1	INC. DCH ISID2-031A-3 PER DCR 00-1766	SBW	
2	INC. DCH ISID2-031A-2 PER DCR 97-0187		INITIALS ON FILE
3	INC. DCH ISID2-031A-1 FOR DCR 91-0011		INITIALS ON FILE
4	ISSUED FOR SECOND 10 YEAR ISI PROGRAM	JUN RJC	TRN WDB MDP ECC
NO.	DATE	REVISIONS	BY
DATE	DESIGNED	DATE	DATE
DAVIS-BESSE NUCLEAR POWER STATION UNIT NO. 1			
INSERVICE INSPECTION DIAGRAM			
MAKE-UP & PURIFICATION SYSTEM			
DRAWING NO.		REV.	
ISID2-031A		3

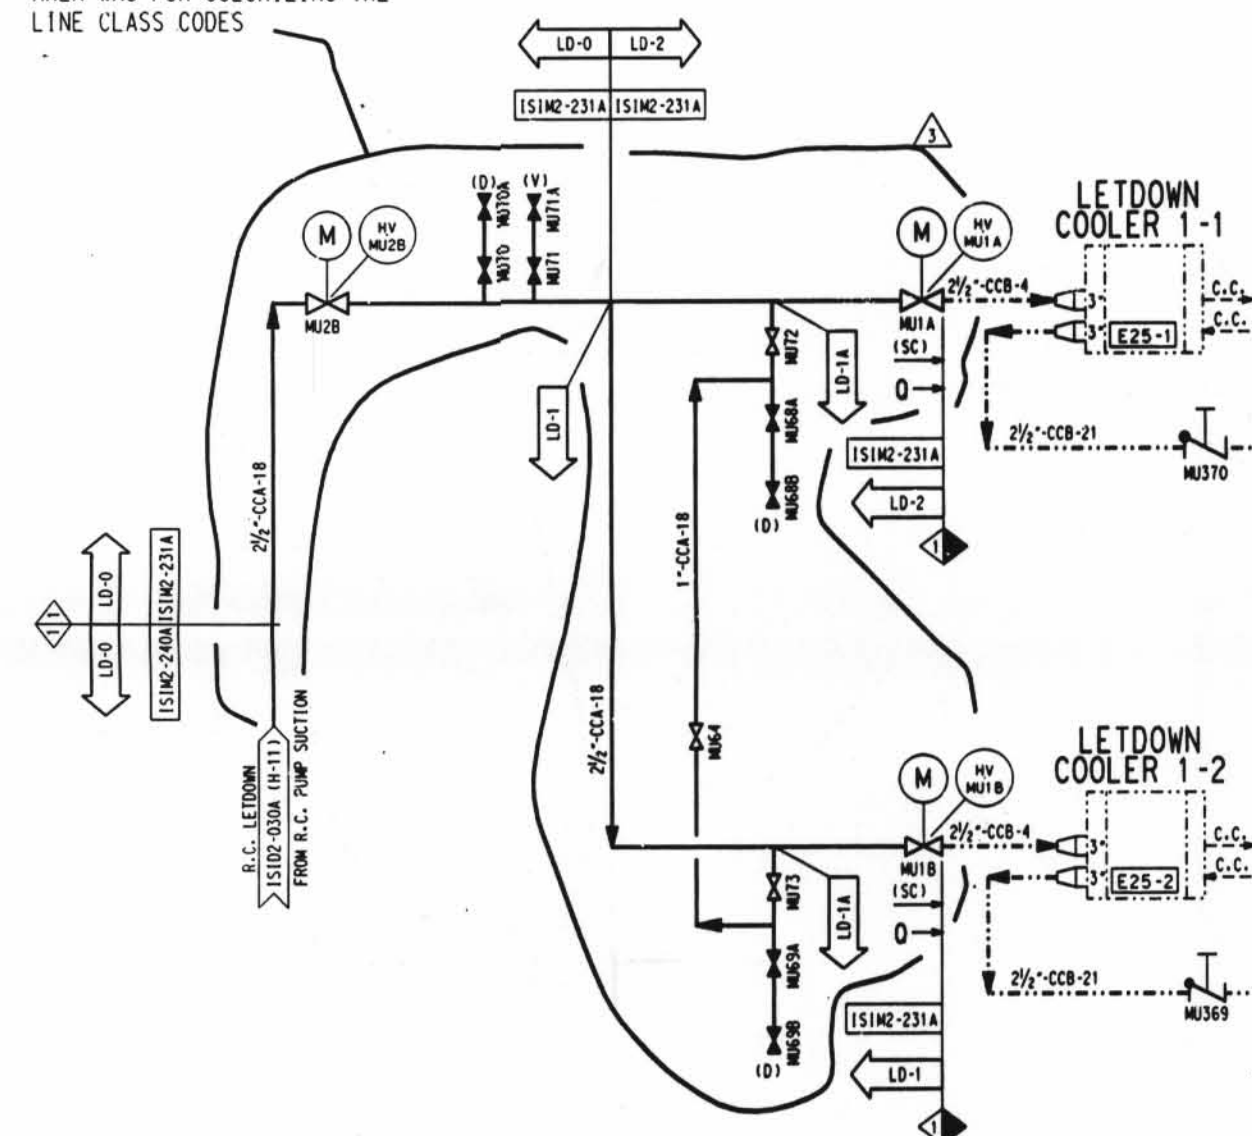
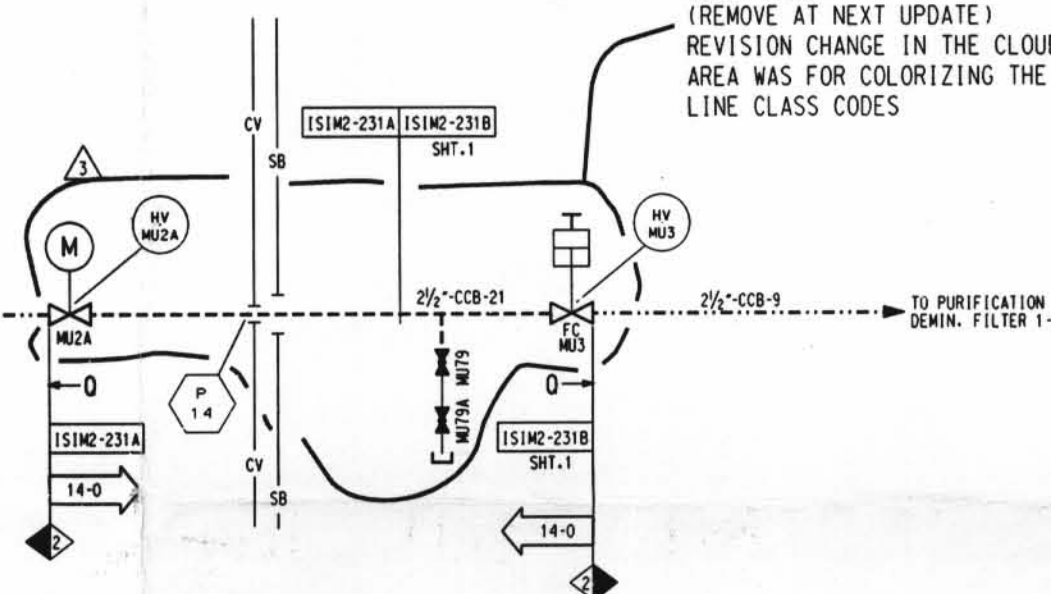
INFO. NOTE:
(REMOVE AT NEXT UPDATE)
REVISION CHANGE IN THE CLOUDED
AREA WAS FOR COLORIZING THE
LINE CLASS CODES

INFO. NOTE:
(REMOVE AT NEXT UPDATE)
REVISION CHANGE IN THE CLOUDED
AREA WAS FOR COLORIZING THE
LINE CLASS CODES
